**Industry Comments on Proposed Revision to
NRC Safety Evaluation on NEI 04-07**

Figure 1: Increase in ZOI size for Transco RMI due to application of URG scaling equation

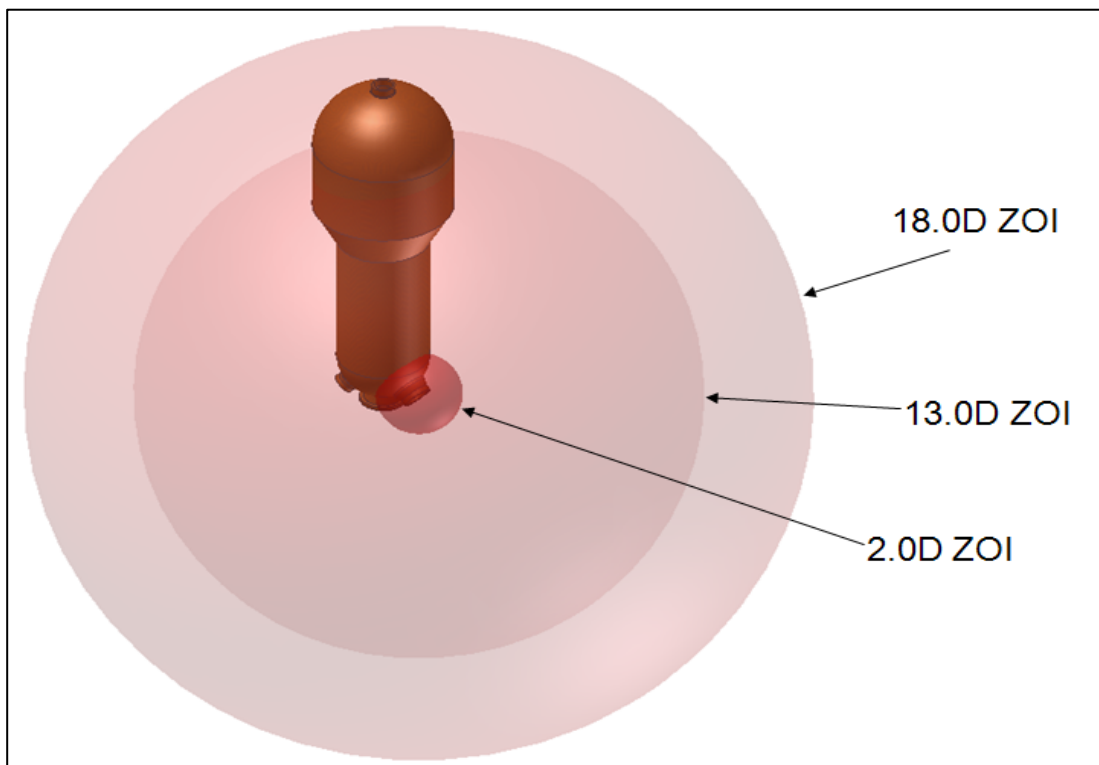
Note that using the scaling equation could result in significantly more RMI debris than has currently been analyzed under the existing methodology. For example, if the destruction pressure is scaled for the diameter of the lower and upper portions of a steam generator, the ZOI size would increase from 2D to 13D on the lower portion of the steam generator (11.3 ft diameter) and 18D on the upper portion of the steam generator (14.6 ft diameter). As shown in the following figure, applying this equation for RMI would result in the entire steam generator being enveloped within the ZOI. This would increase the quantity of RMI debris from approximately 2,500 ft² (38 ft³) to over 60,000 ft² (900 ft³). Nine Hundred cubic feet of crumpled RMI foils could cause a significant impact on ECCS performance as noted above. Selective dismissal of the application of scaling to certain types of RMI was not recommended by the URG and the associated SER for BWRs. Selective dismissal of the application of the

scaling to certain types of RMI as recommended by the NRC staff in the draft revision to the NEI 04-07 SER is not appropriate, and would be in direct contradiction to the previous NRC position.
